AKH ECO APPARELS LTD.

- Extended Buildings

07 September 2021

Observations

Design Report

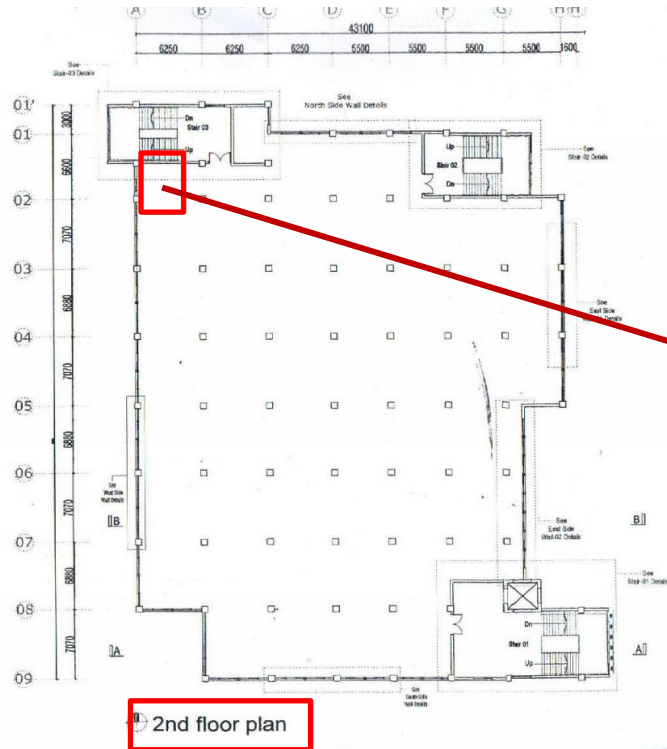
A design report has been provided which was prepared using a FEM based analysis model. However, the model has not been provided for review. In addition, the details calculation of concrete strength evaluation not provided in the design report. Also, concrete strength in cylinder test reports did not meet the equivalent criteria of BNBC 5.6 and 5.12. Building engineer is required to update the design report in compliance BNBC-2006, Part 6, Section 1.9.1.1. And, submit along with software-based analysis model for review.

Water ponding due to poor roof drainage system

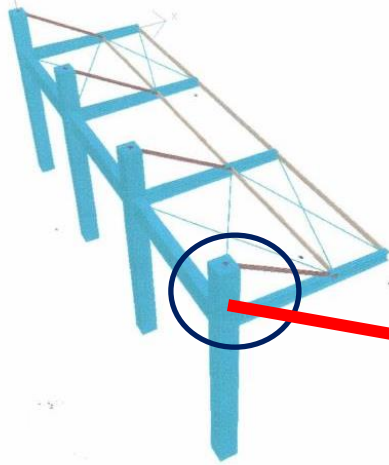
Water ponding observed on roof. Poor roof drainage system observed. Building engineer is required to improve the roof drainage system.

Irregular load path of the Canopy

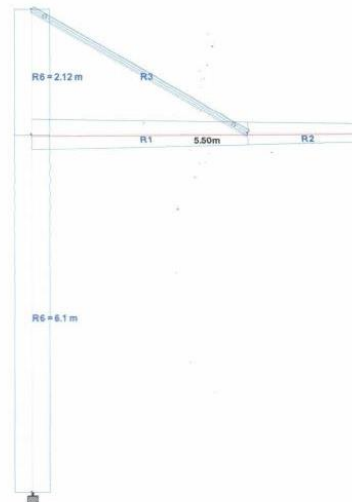
Connection between steel rafter and the brick façade wall.

Two end beams are shown connect to column in the design report but, they were connected to brick wall in as-built condition. Hence, the load path is not regular. Building engineer is required to check the adequacy of the connection of canopy.

**Adequacy of foundation & RC member
not addressed in design report**

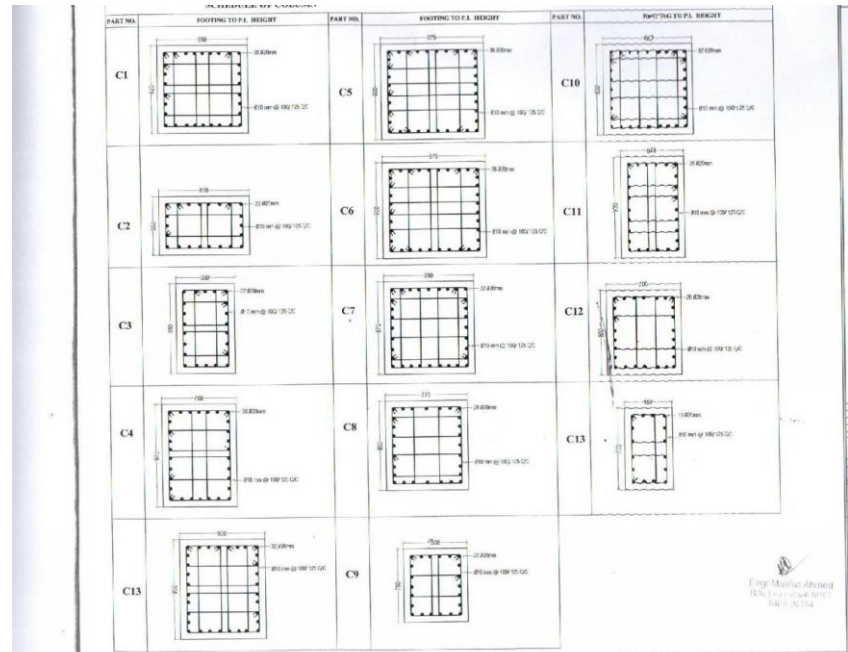
Adequacy of foundation & RC member not address in design report. Building engineer is required to prepare design report in compliance with section 1.9.1.1 (part 6 BNBC).
